Access Compliance Report

Public Rights-of-Way

(Curb Ramps)

Intersection ID: 30018	Main Street: W_MALLARD_CREEK_CHURCH_RD	Cross Street: BERKELEY_PLACE_DR	Location: NW
ADA ID: 8B084FFC8394	Ramp Type: Perp	Initial Pass/Fail: Fail	Overall Compliance: No
Severity Score: 26.25			
Codes/Mitigation Info/Possible Solution		Field Measurements/Component Compliance

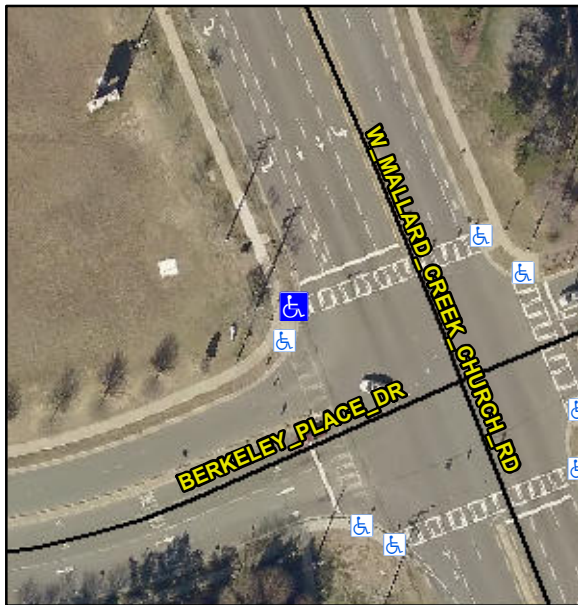
Compliance	Description	Data	Compliance	Description	Data
N/A	Ramp Length (in)	79.0	No	Ramp Slope (%)	20.0
Yes	Ramp Width (in)	48.0	Yes	Ramp XSlope (%)	3.7
N/A	Flare Type LT	N/A	N/A	Flare Type RT	N/A
N/A	Flare Slope LT (%)	N/A	N/A	Flare Slope RT (%)	N/A
N/A	Flare Traversable LT?	N/A	N/A	Flare Traversable RT?	N/A
N/A	Landing Length (in)	N/A	N/A	DWS Provided?	N/A
N/A	Landing Width (in)	N/A	N/A	DWS Contrast?	N/A
N/A	Landing Slope (%)	N/A	N/A	DWS Length (in)	N/A
N/A	Landing X Slope (%)	N/A	N/A	DWS Full Width?	N/A
N/A	Landing Curb? (Y/N)	N/A	N/A	DWS Offset (in)	N/A
N/A	Shared Landing?	N/A			
N/A	Gutter Ponding?	N/A	N/A	Gutter Slope (%)	N/A
N/A	Gutter Lip Ht (in)	N/A	N/A	Gutter X Slope (%)	N/A
N/A	Painted X Walk1?	Yes	N/A	Painted X Walk2?	N/A
	X Walk 1 Direction	To E		X Walk 2 Direction	N/A
N/A	X Walk 1 Width (in)	105.0	N/A	X Walk 2 Width (in)	N/A
	X Walk 1 Slope (%)	1.5		X Walk 2 Slope (%)	N/A
	X Walk 1 X Slope (%)	3.8		X Walk 2 X Slope (%)	N/A

Remove & Replace Entire Ramp.
